Tender PZA170421T-10056- Questions and answers

v. 12/06/2023

PROJECT TITLE:
Al-Sheikh Saad Girls School
External Works

Wall Section [3-3] Modified.
Scale: 1-20

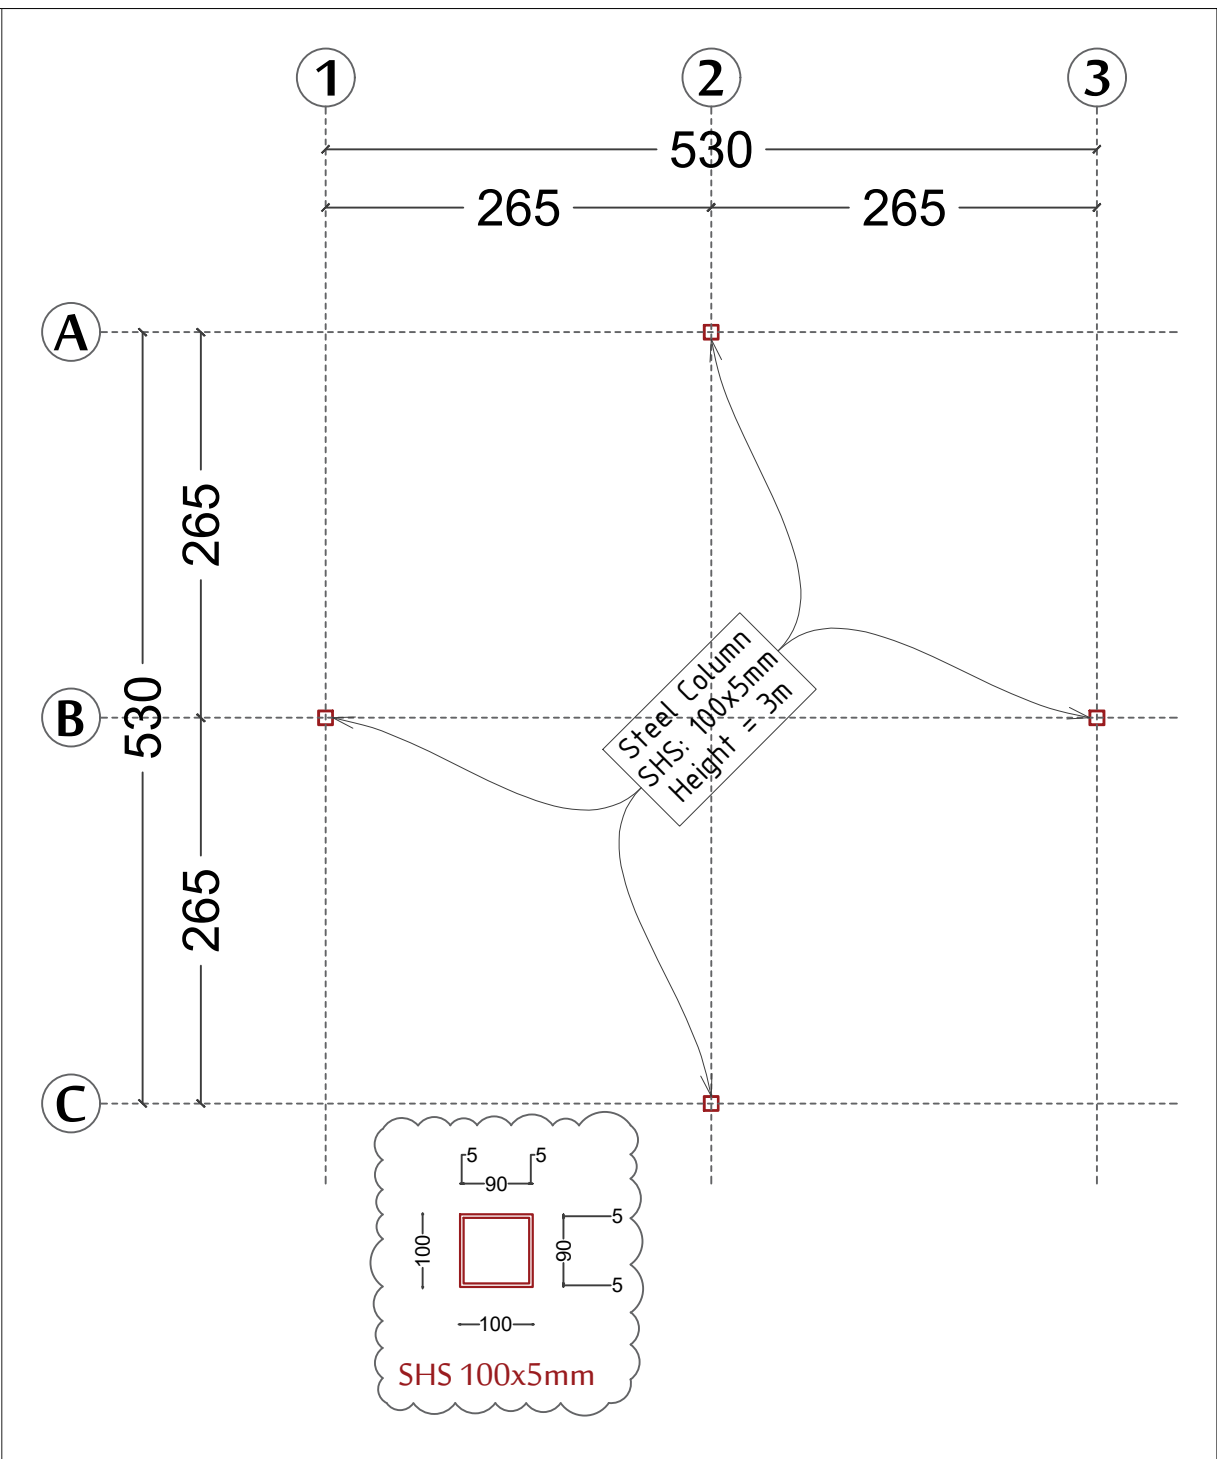
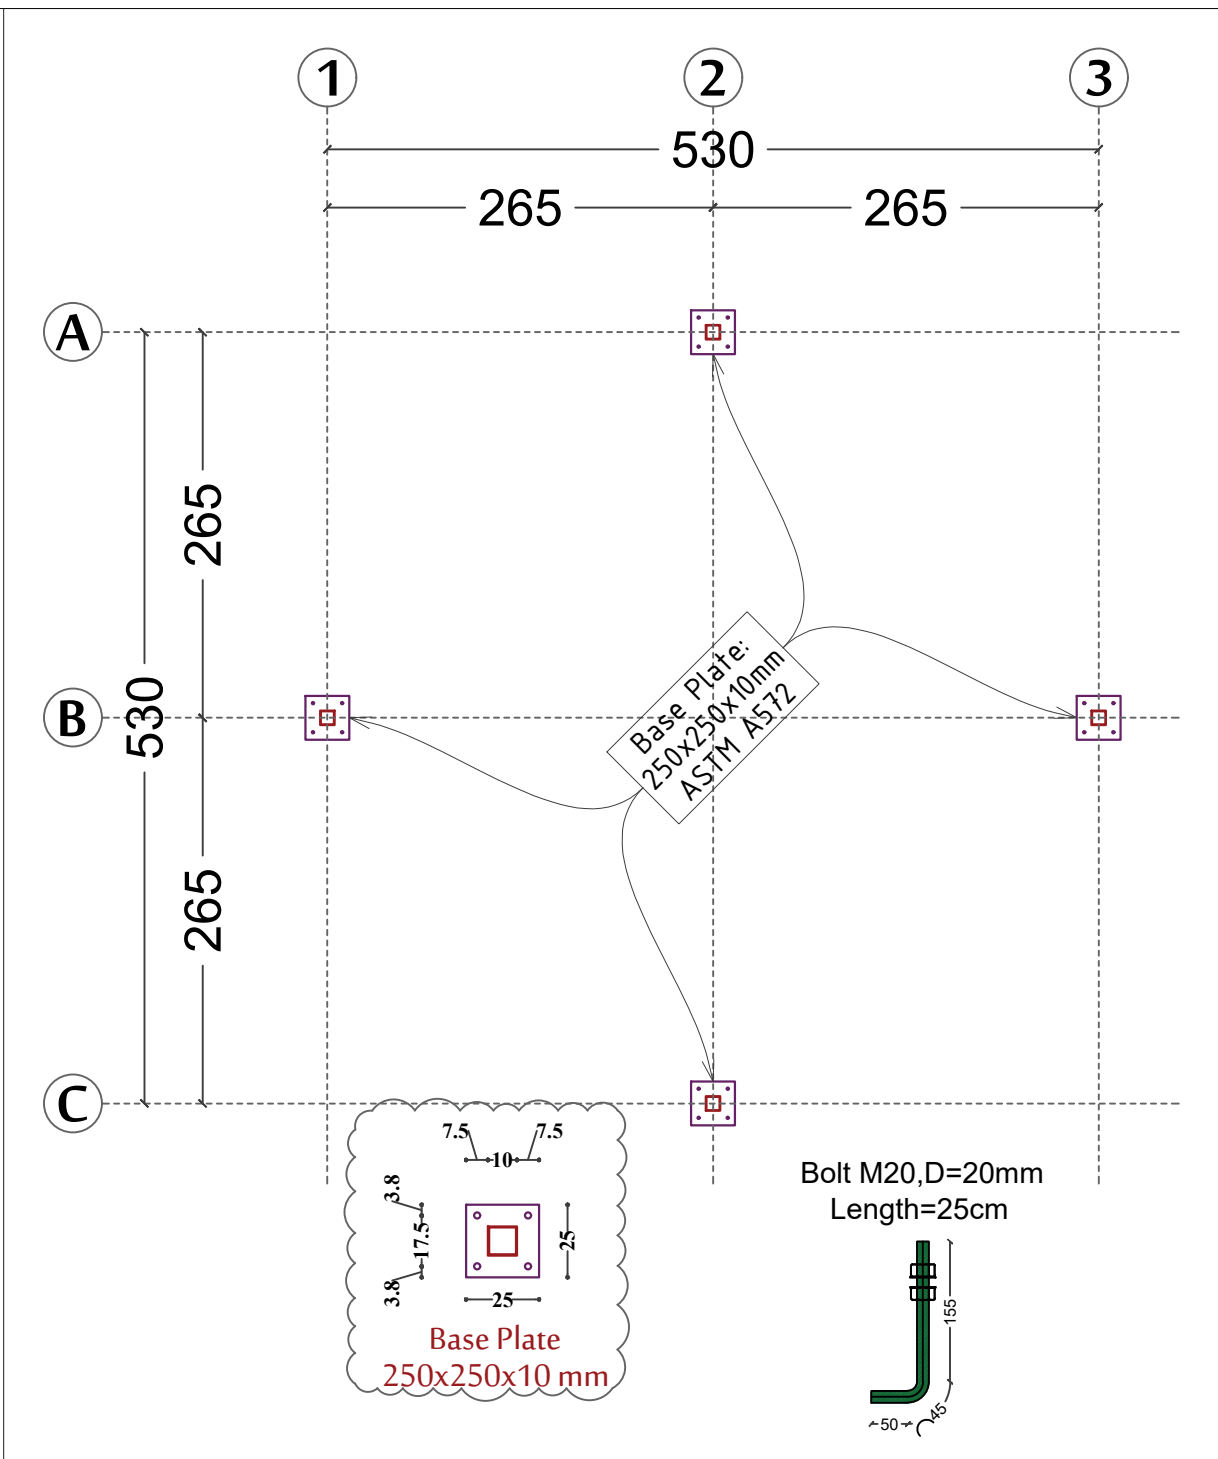
Question 8: Regarding wall section (3-3) on the upper side, will it be replacing the existing wall, or will it be constructed adjacent to the wall location?

ERRATUM#3: *Please refer to attachment# 1 for modified wall section (3-3) which shall be constructed adjacent the existing wall.*
